ROCHESTER PUBLIC WORKS DEPARTMENT

TRANSMITTAL LETTER NO.: (24-01)

STANDARD SPECIFICATIONS BOOK

SUBJECT: Sewer Specifications S100, Watermain Specifications W200, Service Connections C150, Engineering Standards

DEPARTMENT OF PUBLIC WORKS CITY OF ROCHESTER, MINNESOTA STRUCTURE TYPE 2 (STORM SEWER)			
 CITY ENGINEER			
SHT 1 OF 2 SHTS	DATE REVISED 1/26/24	PLATE NO. 1-02	REV. L

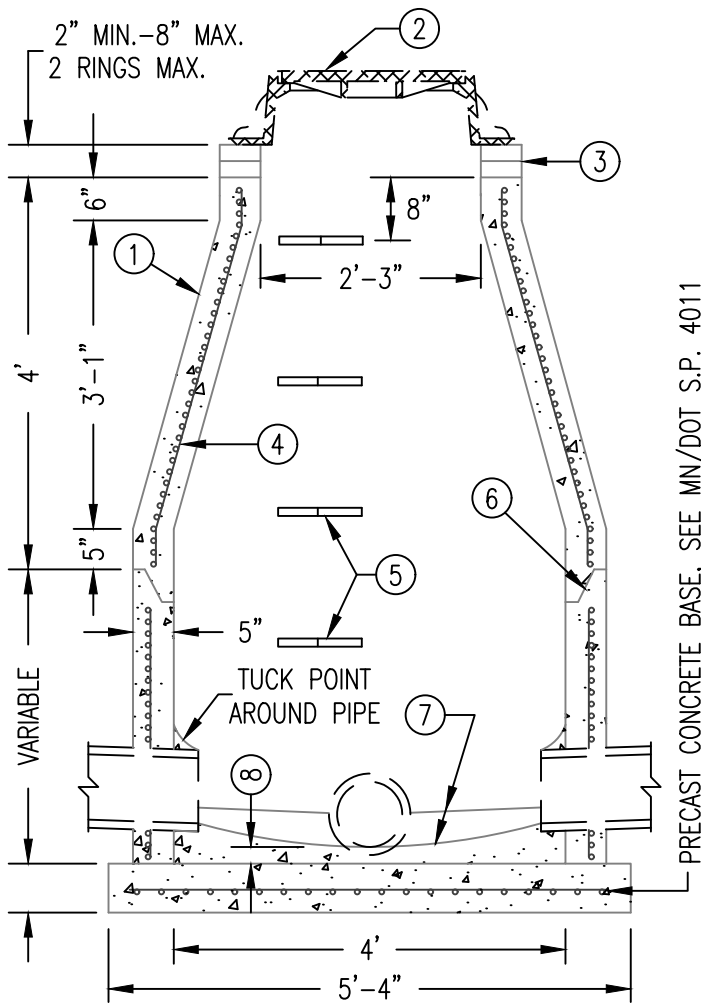
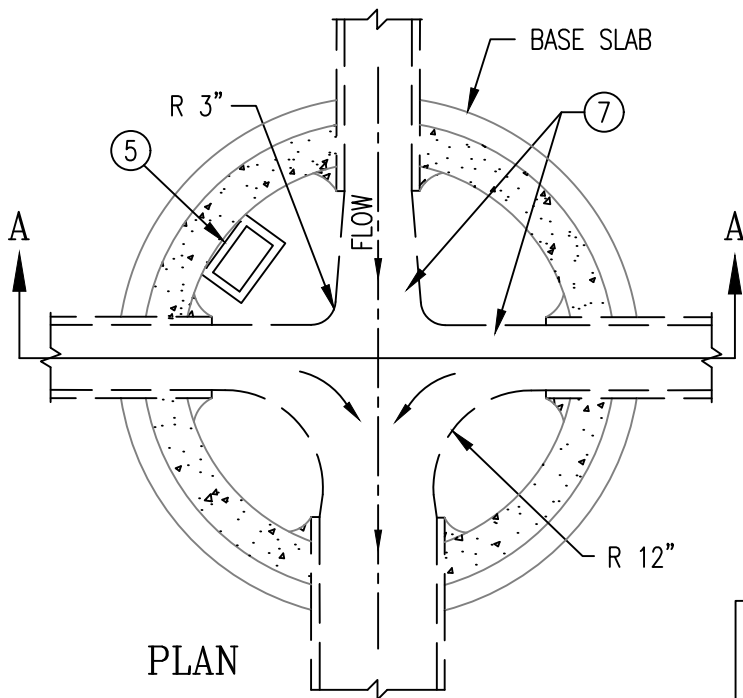
- 1-01N** Updated “NOTE 2” to change “ADJUSTING RINGS” to “CONCRETE ADJUSTING RINGS”
- 1-02L** Updated “NOTE 3” to change “ADJUSTING RINGS” to “HDPE ADJUSTING RINGS”
Page 1

DEPARTMENT OF PUBLIC WORKS CITY OF ROCHESTER, MINNESOTA STRUCTURE TYPES 2 AND 2A (SANITARY SEWER)			
<i>Dylan S. Dahl</i> CITY ENGINEER			
SHT 2 OF 2 SHTS	DATE REVISED 1/26/24	PLATE NO. 1-02	REV. L

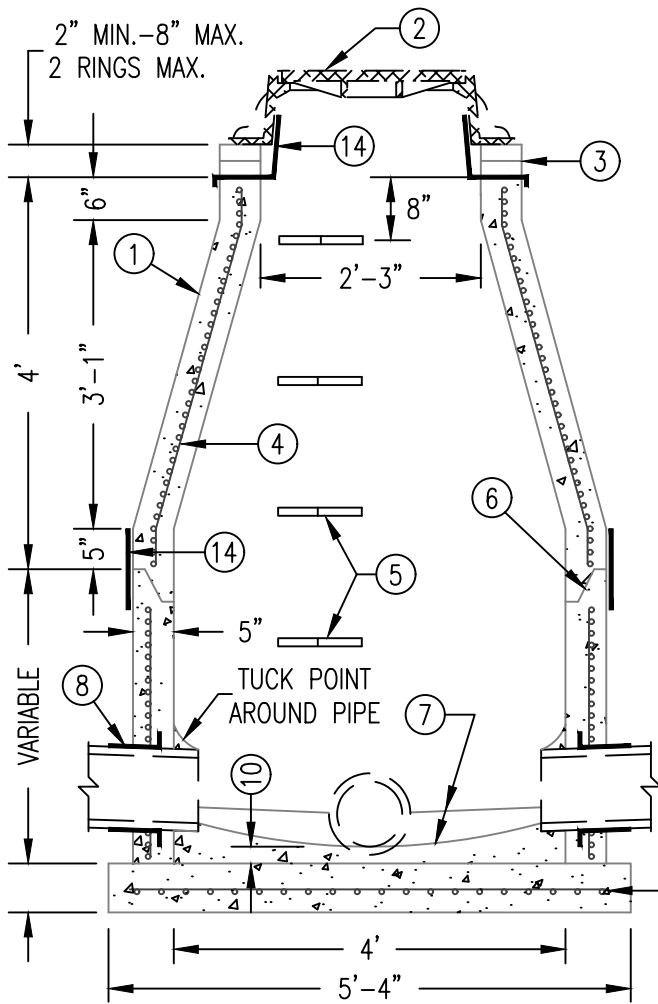
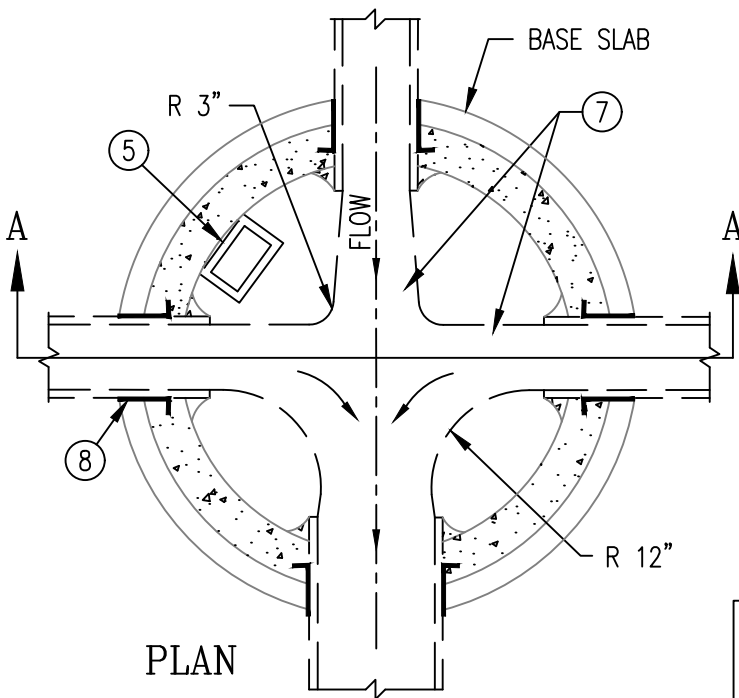
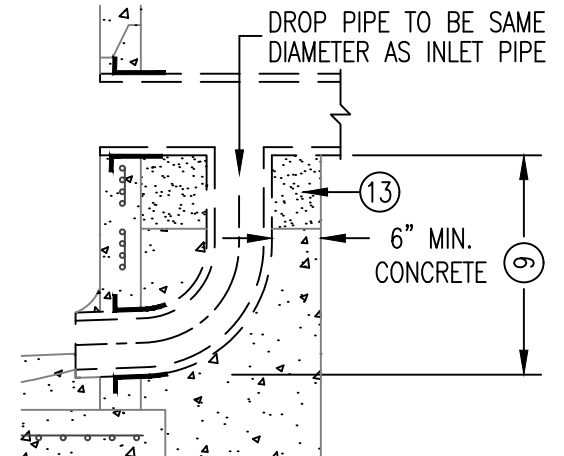
- 1-02L** Updated “NOTE 3” to change “ADJUSTING RINGS” to “HDPE ADJUSTING RINGS”
Page 2
- 1-03M** Updated “NOTE 3” to change “ADJUSTING RINGS” to “HDPE ADJUSTING RINGS”

DEPARTMENT OF PUBLIC WORKS CITY OF ROCHESTER, MINNESOTA			
STRUCTURE TYPE 4 (XX in.)			
<i>Dylan S. Dahl</i> CITY ENGINEER			
SHT 1 OF 2 SHTS	DATE REVISED 1/26/24	PLATE NO. 1-04	REV. L

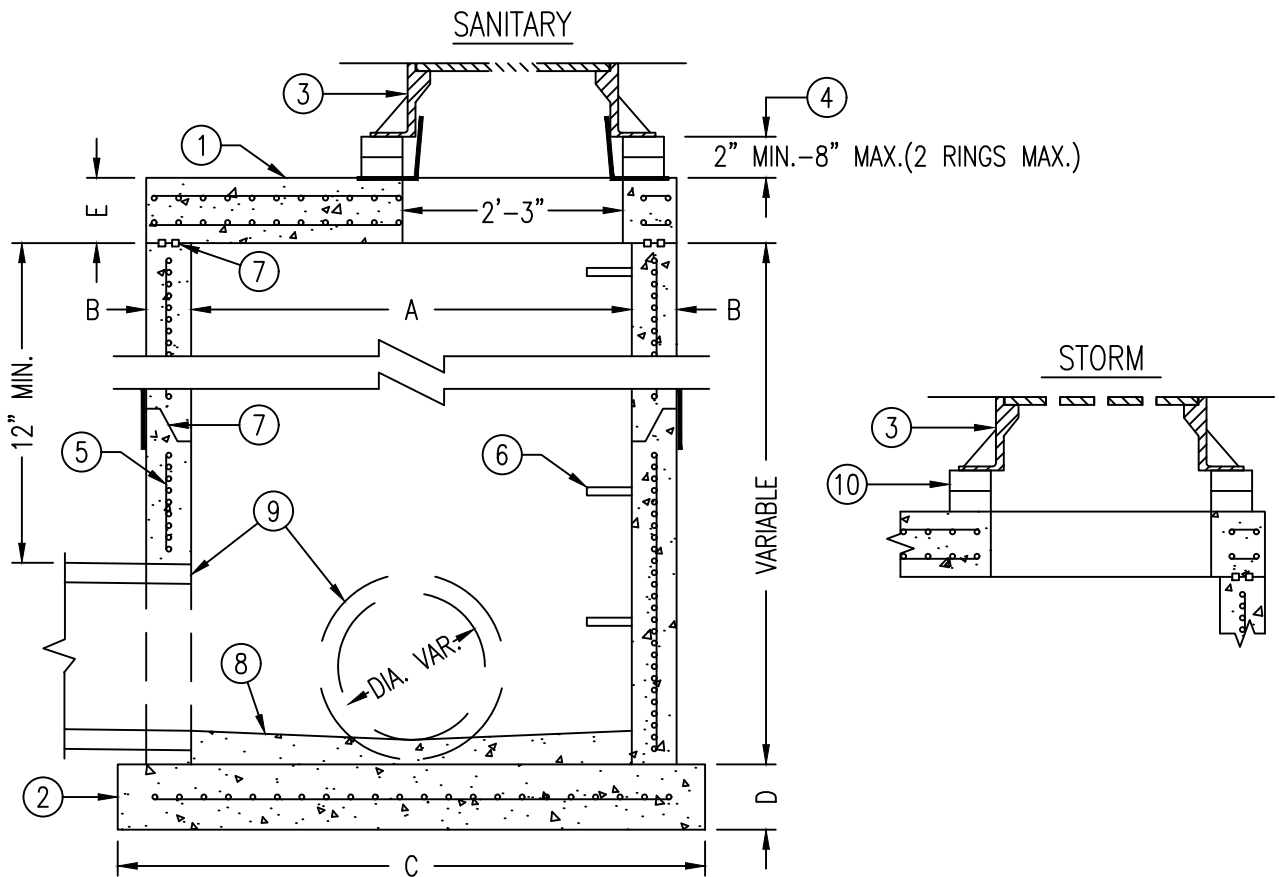
- 1-04L** Updated “NOTE 4” to change “ADJUSTING RINGS” to “HDPE ADJUSTING RINGS”
Page 1
- 1-04L** Updated revision letter only
Page 2
- 1-06G** Updated “NOTE 4” to change “ADJUSTING RINGS” to “HDPE ADJUSTING RINGS”, removed adjusting ring description below node “4” in side elevation detail

DEPARTMENT OF PUBLIC WORKS CITY OF ROCHESTER, MINNESOTA CONCRETE STRUCTURE ADJUSTING RINGS			
 CITY ENGINEER			
SHT 1 OF 2 SHTS	DATE REVISED 1/26/24	PLATE NO. 1-13	REV. H

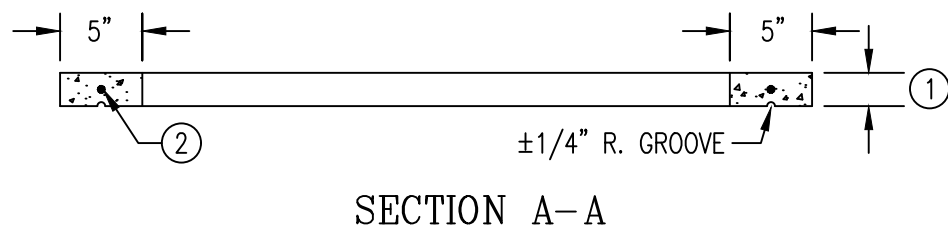
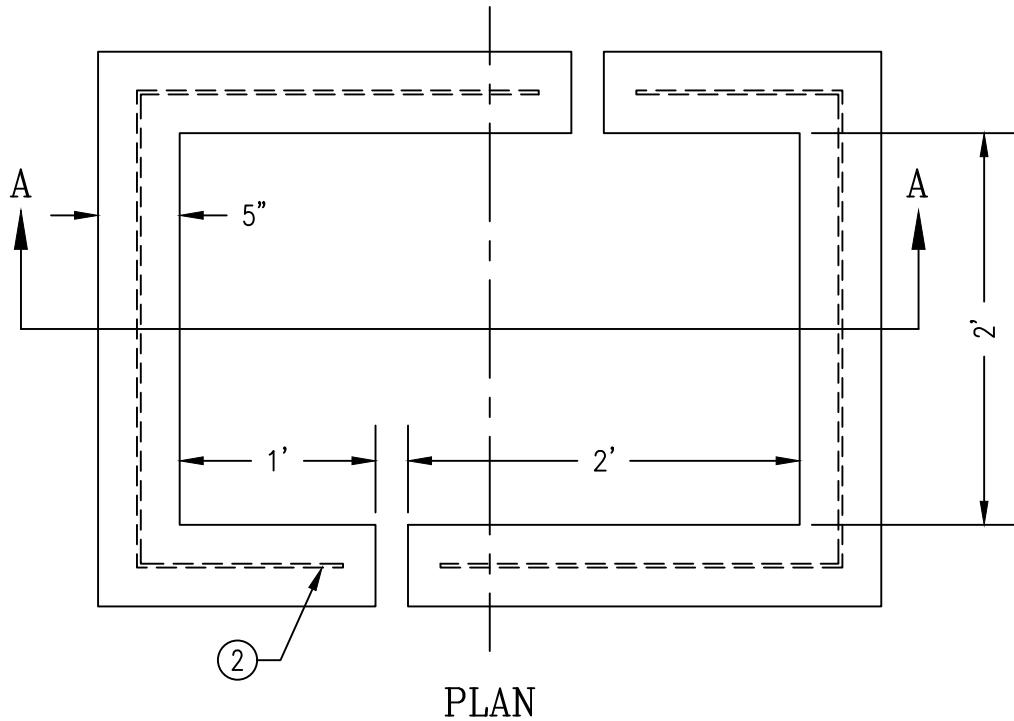
- 1-13H** Updated “NOTE 1” to change from 2” minimum and 8” maximum to 2” minimum and 9” maximum and added standards for reconstructing inplace structures
Page 1

- ① VARIABLE THICKNESS OF 2" MINIMUM AND 9" MAXIMUM ON NEW DRAINAGE STRUCTURES AND 12" MAXIMUM WITH 3 RINGS FOR RECONSTRUCTING INPLACE STRUCTURES
- ② REINFORCEMENT SHALL BE A SINGLE HOOP OF #8 GAGE STEEL WIRE
- 3. SEE MN/DOT S.P. 4010

DEPARTMENT OF PUBLIC WORKS CITY OF ROCHESTER, MINNESOTA HIGH DENSITY POLYETHYLENE (HDPE) ADJUSTING RINGS			
 CITY ENGINEER			
SHT 2 OF 2 SHTS	DATE REVISED 1/26/24	PLATE NO. 1-13	REV. H

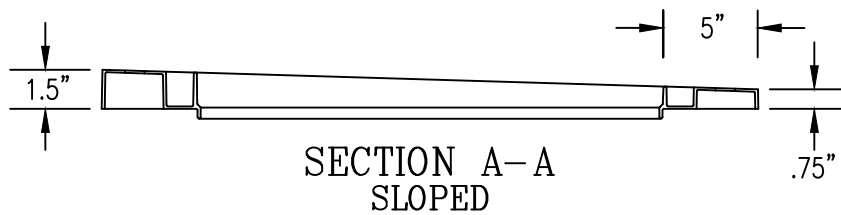
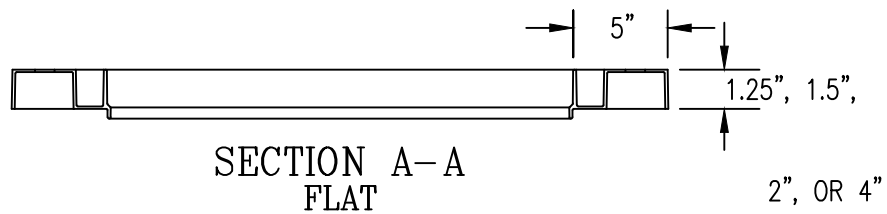
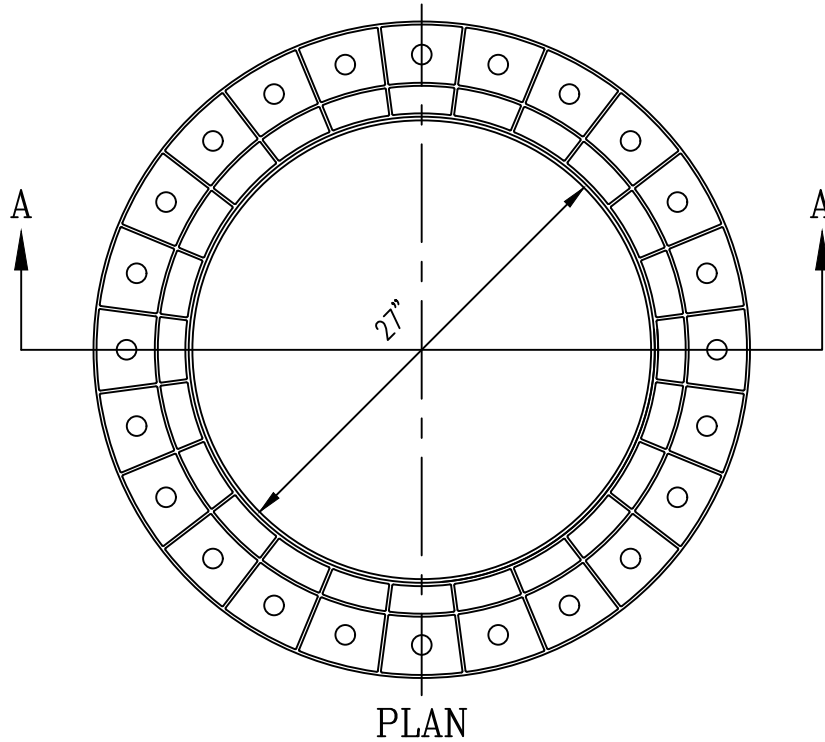
- 1-13H** Changed plate title to “HIGH DENSITY POLYETHYLENE (HDPE) ADJUSTING RINGS”, added “NOTE 3”
Page 2
- 2-09O** Updated to reflect pedestrian curb ramps to include concrete landing and 1:12 max ramp

SHT 1 OF 3 SHTS	DATE REVISED 1/26/24	PLATE NO. 2-10	REV. N
-----------------	-------------------------	-------------------	-----------

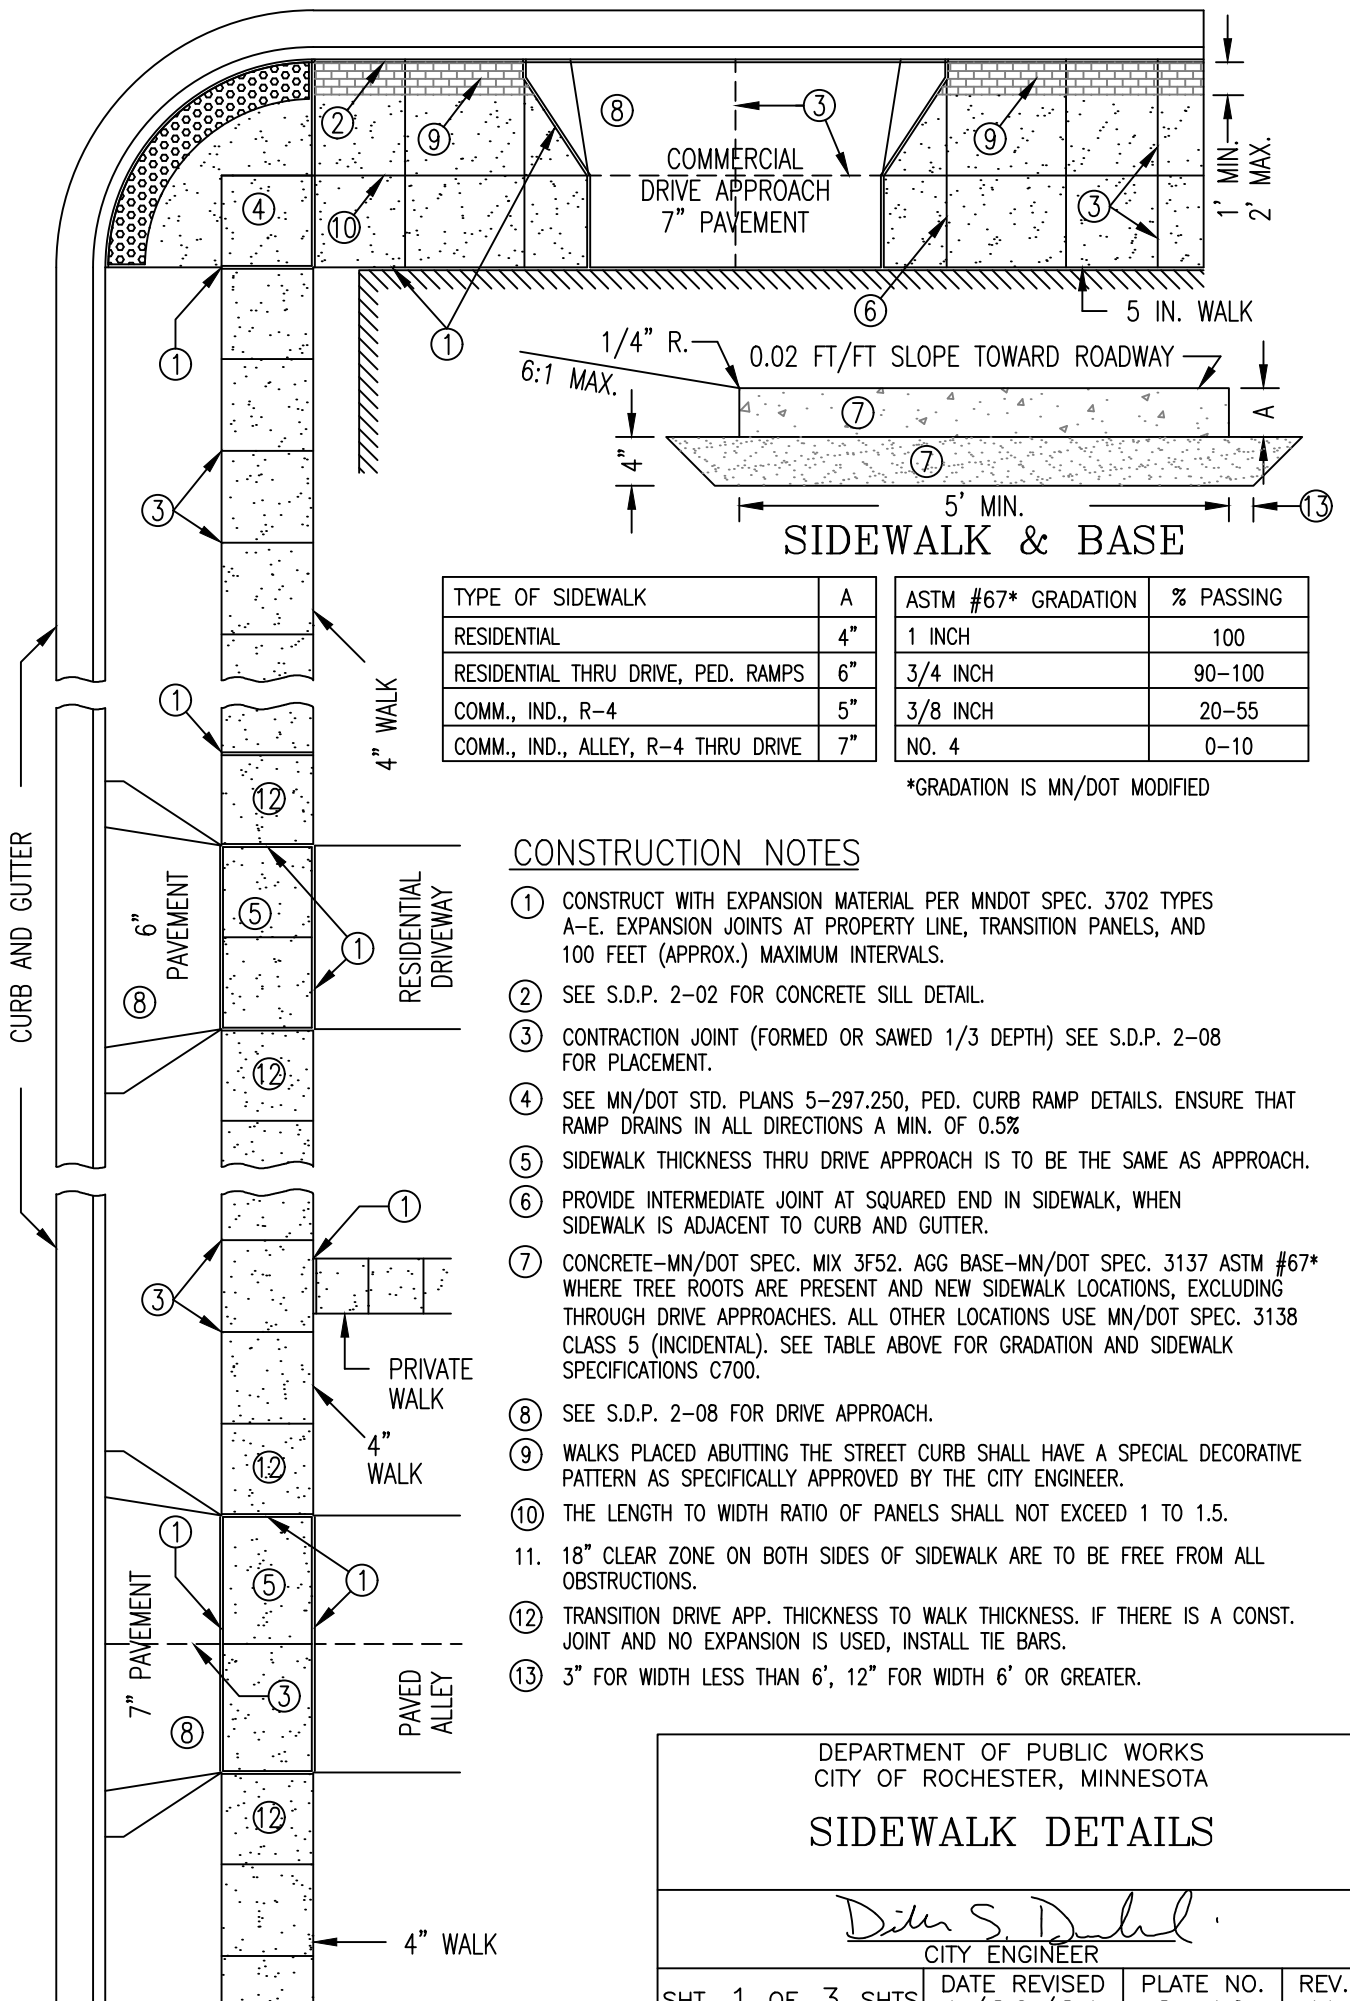
- 2-10N** Revised construction note numbers, updated “NOTE 1” to reflect Mn/DOT changes to expansion materials, updated “NOTE 7” to clarify ASTM #67 requirements
Page 1

DEPARTMENT OF PUBLIC WORKS CITY OF ROCHESTER, MINNESOTA SIDEWALK DETAILS DECORATIVE EDGING			
 CITY ENGINEER			
SHT 2 OF 3 SHTS	DATE REVISED 1/26/24	PLATE NO. 2-10	REV. N

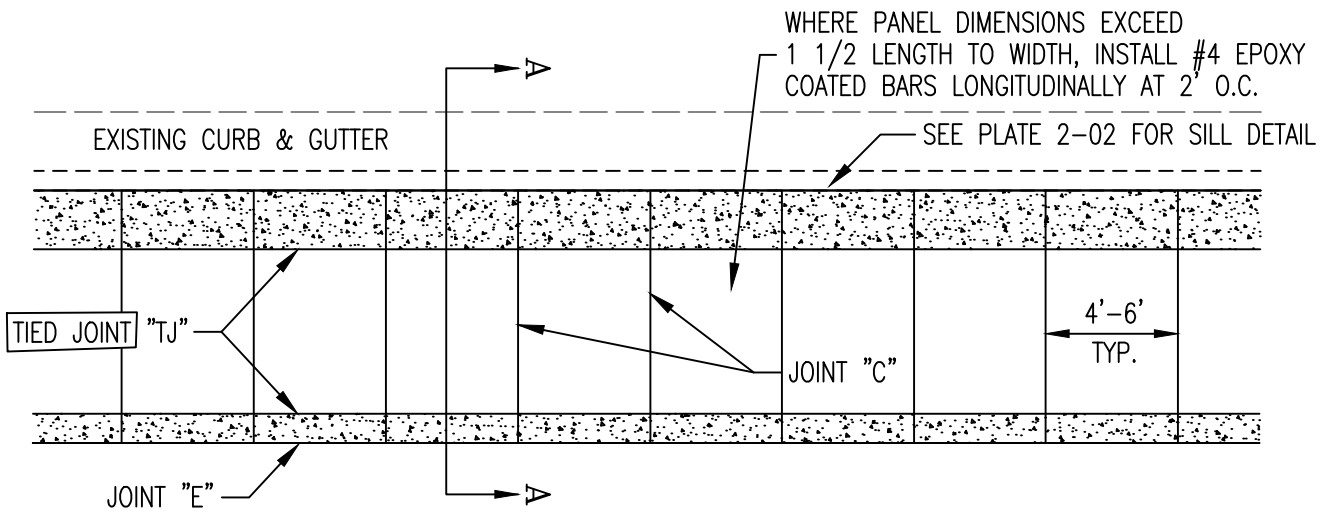
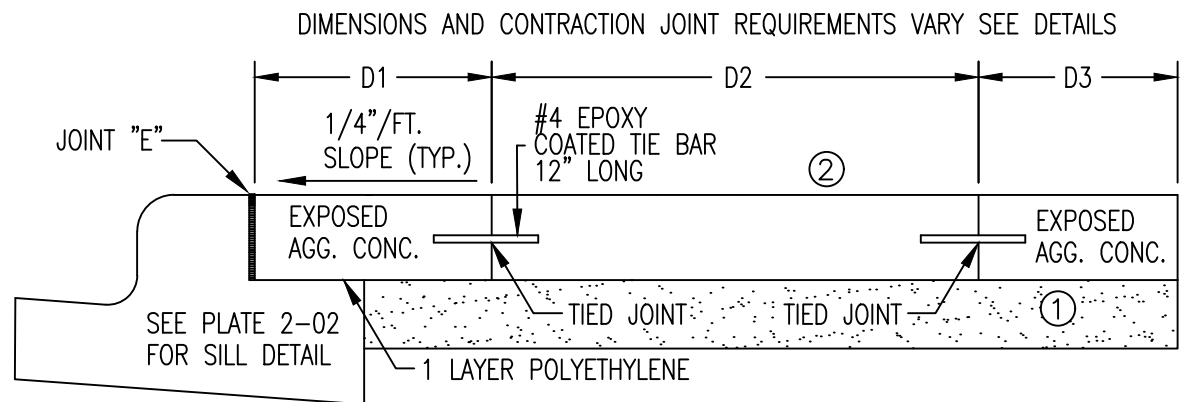
- 2-10N** Added “JOINT E” to Section A-A behind curb and gutter for redundancy
Page 2
- 2-10N** Removed “EXPANSION JOINT “BLDG”” detail, changed “JOINT FILLER” to “TYPE A-E EXPANSION” in “EXPANSION JOINT “E”” detail, changed saw-cut dimension in “CONTRACTRION JOINT “C”” from 3/16” to 1/8”, updated “NOTE 4” to reflect Mn/DOT changes to expansion materials
Page 3
